### ADDENDUM 2

Project Name: Drumheller Downtown Dike Project #2023-03-28	
Date: April 12, 2023	
Item	Detail
<b>A2.1</b>	<p><b>Retaining Wall Package Updated</b></p> <p>The Retaining Wall Package has been updated and included in this Addendum as an attachment. It has been updated to include the dike chainage along the three different retaining walls. This was added to make it easier to reference when constructing the dike.</p>
<b>A2.2</b>	<p><b>Pre-Bid Meeting Question: Construction Schedule Dates</b></p> <p>Answer: There are still outstanding Regulatory Approvals required prior to construction starting on the Downtown Dike. For bidding purposes, Bidders are to assume that Construction can start on July 1, 2023. It is required that the park area behind the Badlands Community Facility (BCF) be completed by the end of 2023, including all landscaping and irrigation (station 0+350 to 0+550). Within the tender documents, it is stated that Substantial Performance must be November 15, 2023, DRFMO will accept bids that have construction finishing in 2024, however, preference will be given to proposals that finish construction in 2023.</p>

# DOWNTOWN DIKE REDI-ROCK RETAINING WALLS DESIGN

**TOWN OF DRUMHELLER**  
**DOWNTOWN DIKE**  
**AQUAPLEX, RIVERVIEW TERRACE, AND RIVERSIDE DRIVE**  
**REDI-ROCK RETAINING WALL DESIGN**  
**RETAINING WALL SECTIONS - 2**

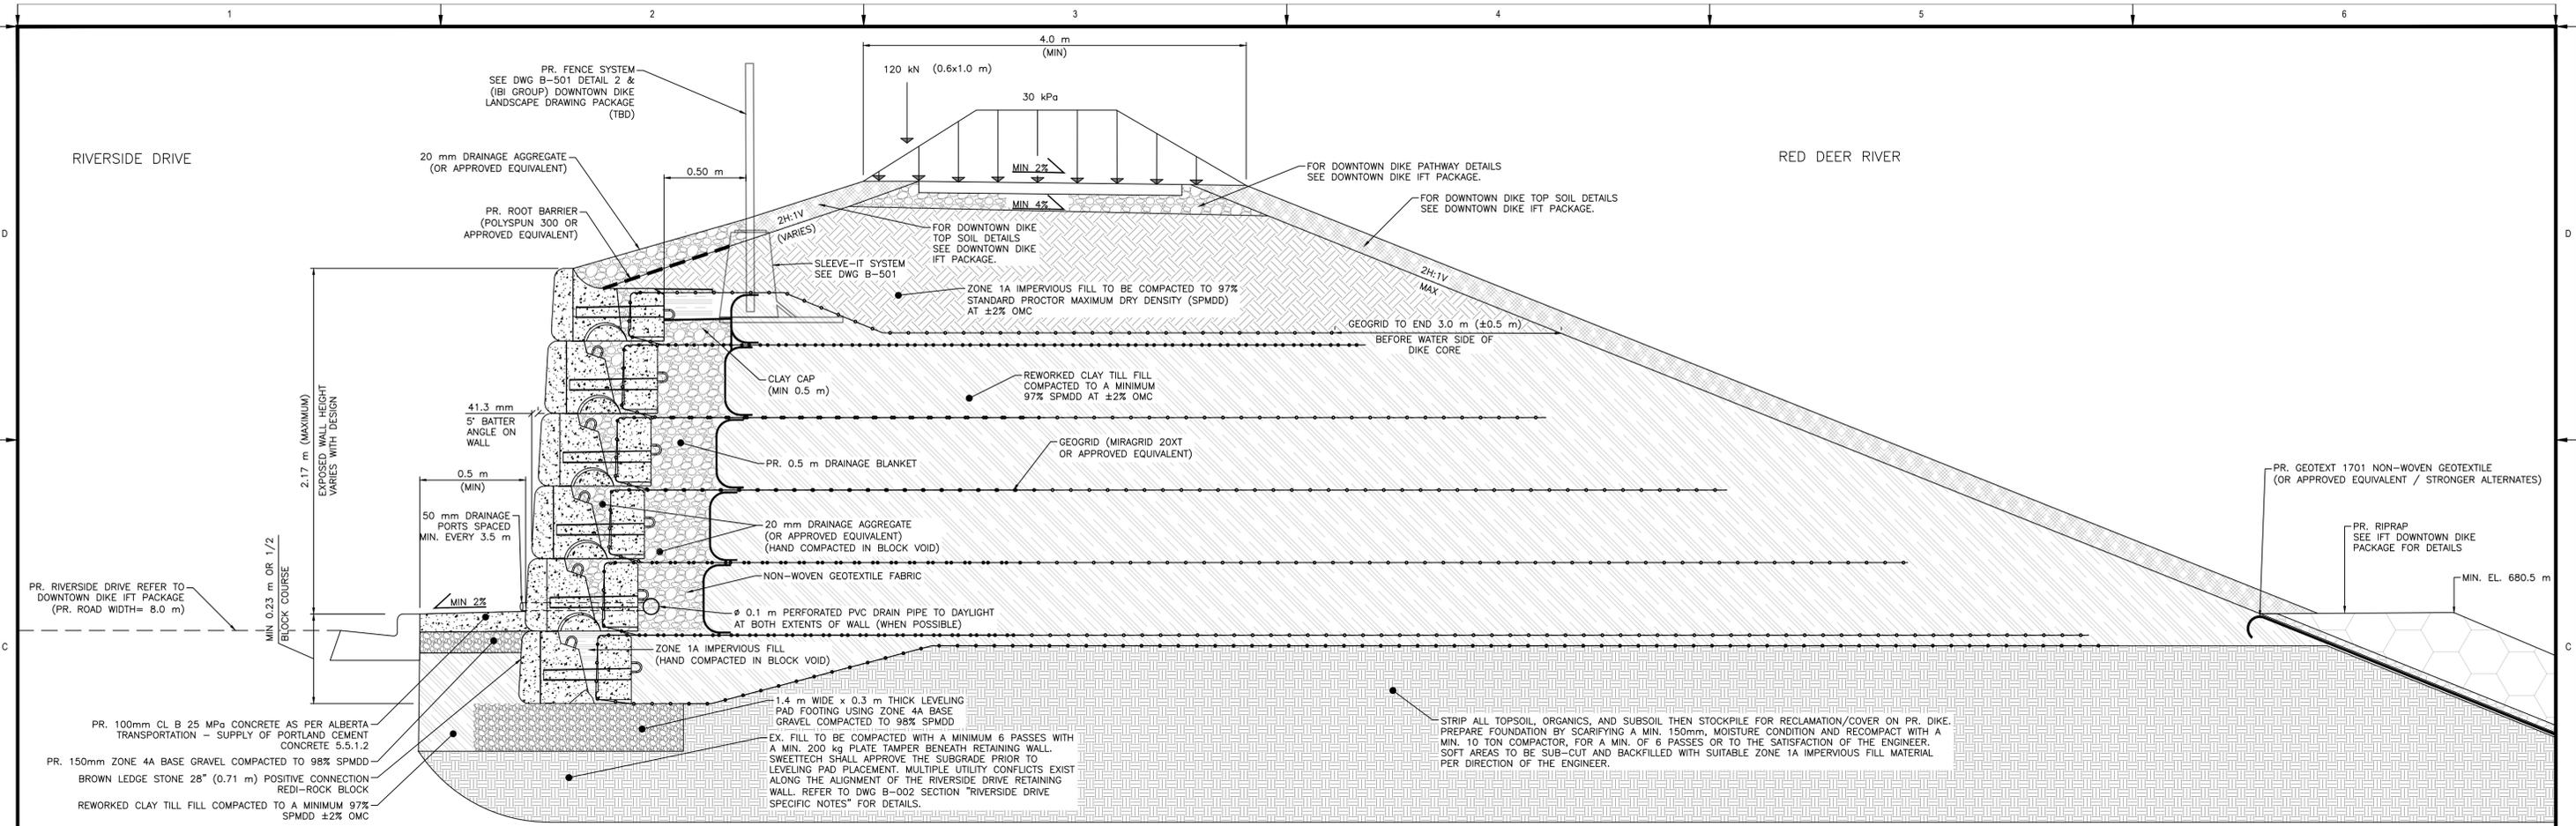
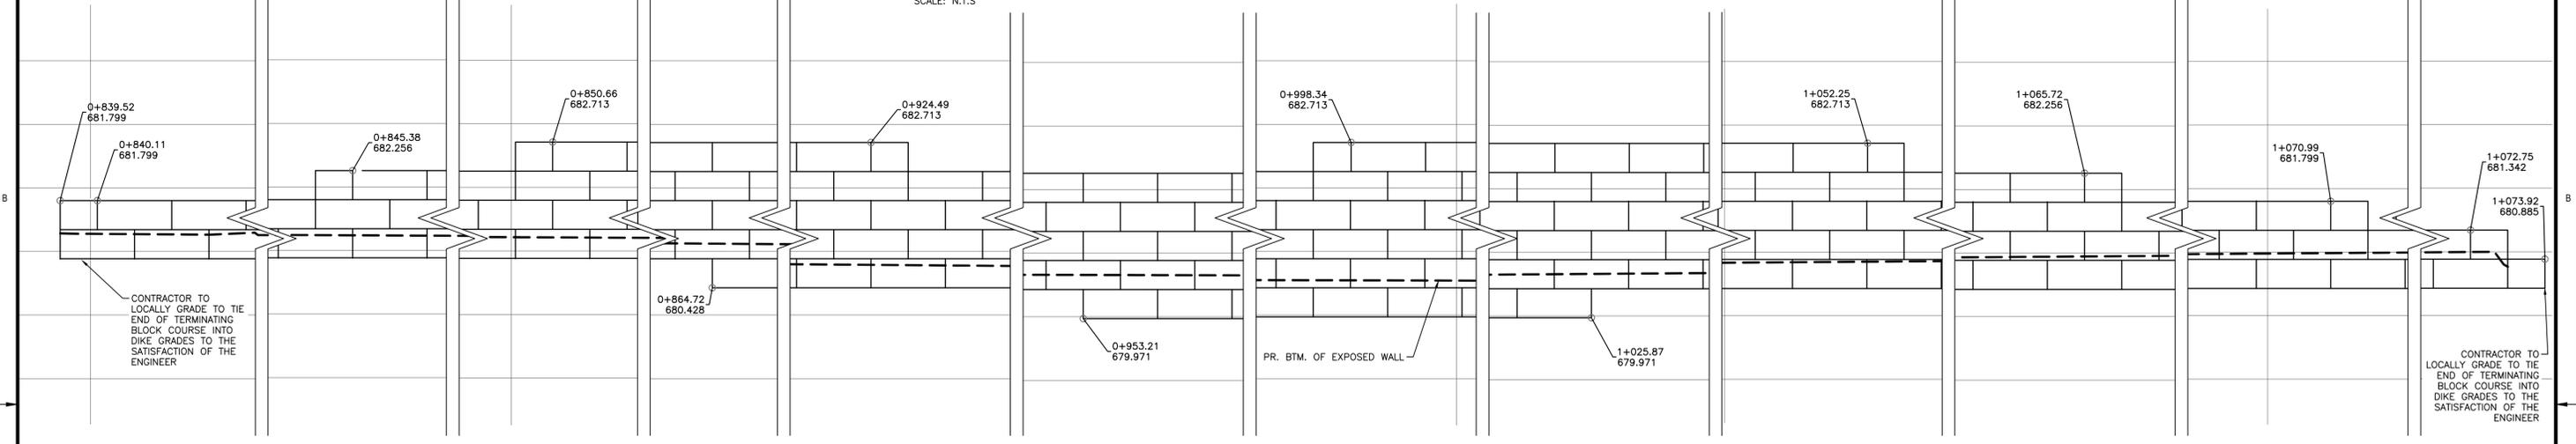
Rev	Date	Des	Dwn	Chk	Description
0	2023-03-20	AO	KS	AO	ISSUED FOR TENDER
1	2023-04-05	AO	KS	AO	ADDED DOWNTOWN DIKE ALIGNMENT & STATIONS
